SELWYN DISTRICT COUNCIL

IN THE MATTER of Private Plan Change 46

Report on submissions relating to Plan Change 46

**Gill Logan's request to lift the deferred status from
Living 2A zoned land at Bangor Road, Darfield**

Figure 2: Properties within Area 5 compared to PC46 (yellow border).

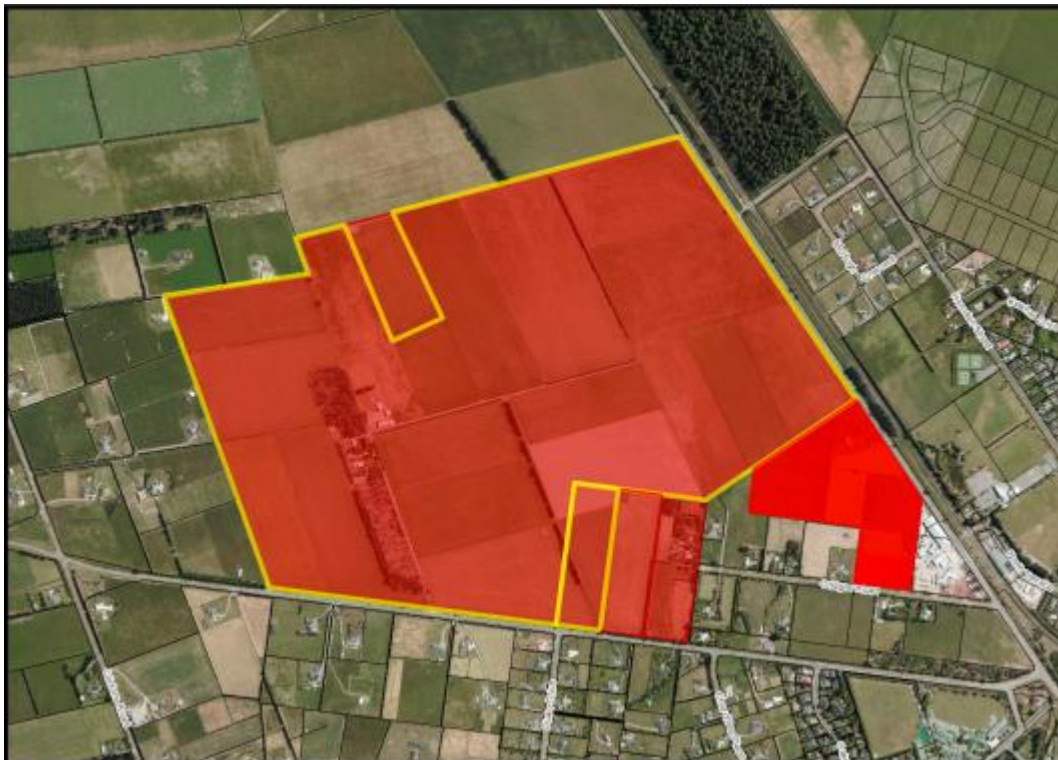
- 5.10 The submission of Ivan Hatton, on behalf of Hatton Investments Ltd, raises the concern that PC46 does not address the entire Area 5 set out in the ODP in Appendix 25 of the District Plan (Township Volume). Also within Area 5 and subject to the Living 2A (Deferred) Zone are Section 1 SO 438579 (which is owned by Selwyn District Council), Lot 1 DP 81020 (which is owned by the submitter), Lot 1 DP 55963, Part Lot 2 DP 18559 and Section 3 Darfield Village Settlement (also known as Lot 3 DP 16539). These are shown in Figure 2, below (taken from the Hatton Investments Ltd submission).

- 5.11 The submission considers that by not including all of Area 5, the ability to provide coordinated development of the entire Area, as set out in **Policy B4.3.28**, is restricted. On this basis the submitter requests that PC46 be declined in its current form. The submitter goes on to suggest that the Plan Change should extend to include all land within Area 5, but notes the possible scope issues with that particular relief sought.

5.14 It is considered that the approach taken by the Applicant to pursue a plan change over only their land, at the exclusion of the balance land within Area 5 does not accord with **Policy B4.3.28**. In this regard PC46 clearly does not provide for the coordinated development of the land within Area 5. Matters of integration and coordination have been raised in other submissions that can be traced back to the fact that not all the land within Area 5 is included within the Plan Change. Most notably connectivity to adjoining land, graduation of density, the location of any future connection to SH73 (including any resultant change in town boundary speed limits) and to a lesser extent reverse sensitivity. These matters are addressed further below.
